NEW STARTER MOTOR FOR ELECTRA GLIDE AND SERVI-CAR

HARLEY-DAVIDSON MOTOR CO.

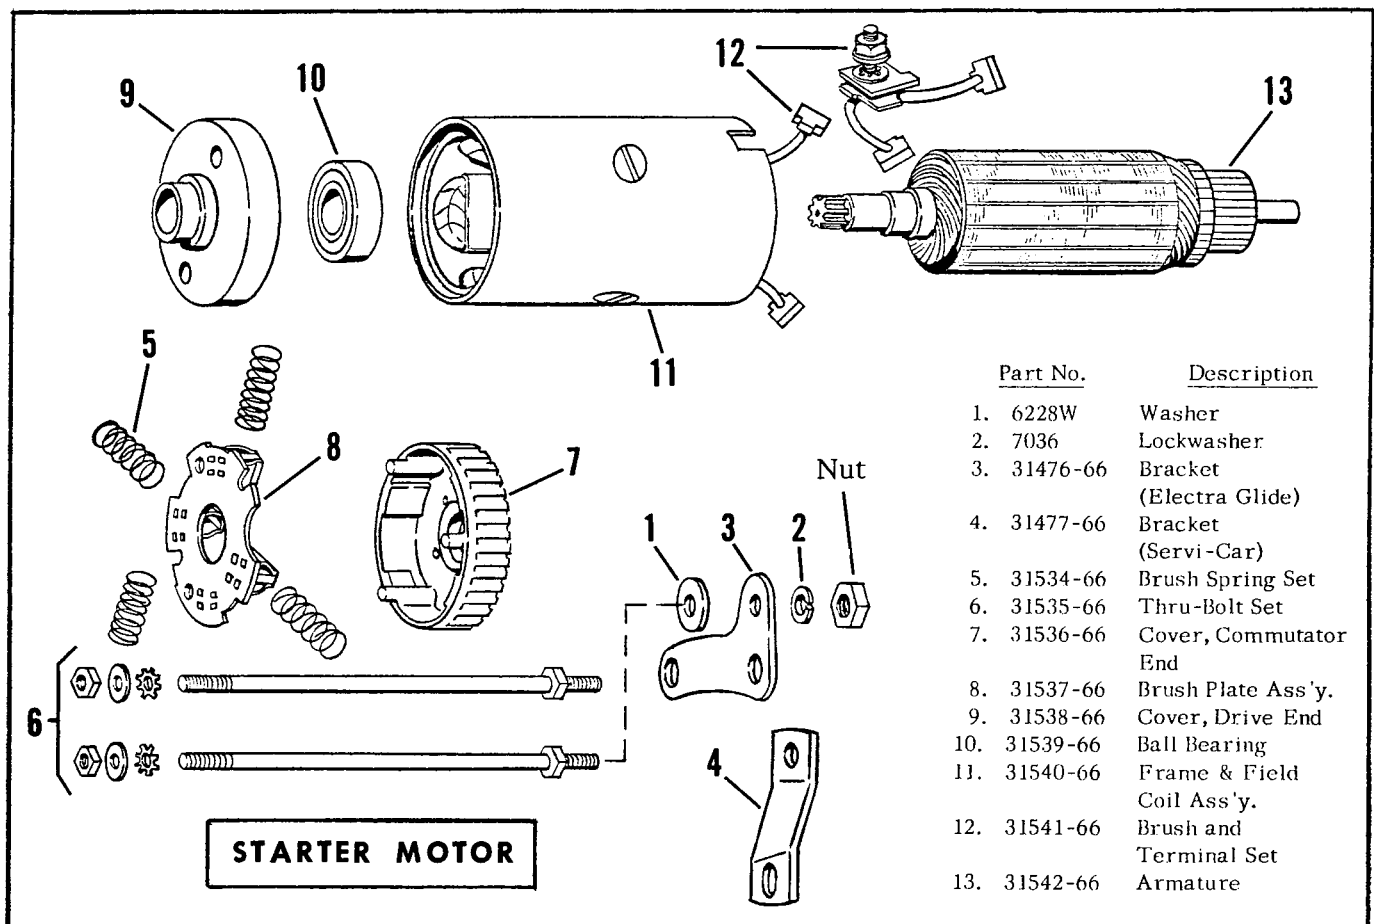
Beginning in February 1966, Prestolite starter motors are being used as original equipment on the Electra Glide model in place of Delco-Remy starter motors. As soon as present stock of Delco-Remy starter motors are used up, this same starter motor will also be used on the Servi-Car model. Delco-Remy motors will no longer be available at that time.

For parts order, the Prestolite starter motor, part No. 31455-64A will be supplied with extra support brackets and hardware to fit all earlier models using Delco-Remy starter motors. Motor components and parts list are shown in illustration.

When installed on 1965 to early 1966 Servi-Cars which used the Delco-Remy starter motor, the starter motor mounting pad on the transmission must be drilled and tapped with 2 extra holes according to instructions included with starter motor. These extra holes are already in the mounting flange on late 1966 Servi-Cars and do not have to be drilled.
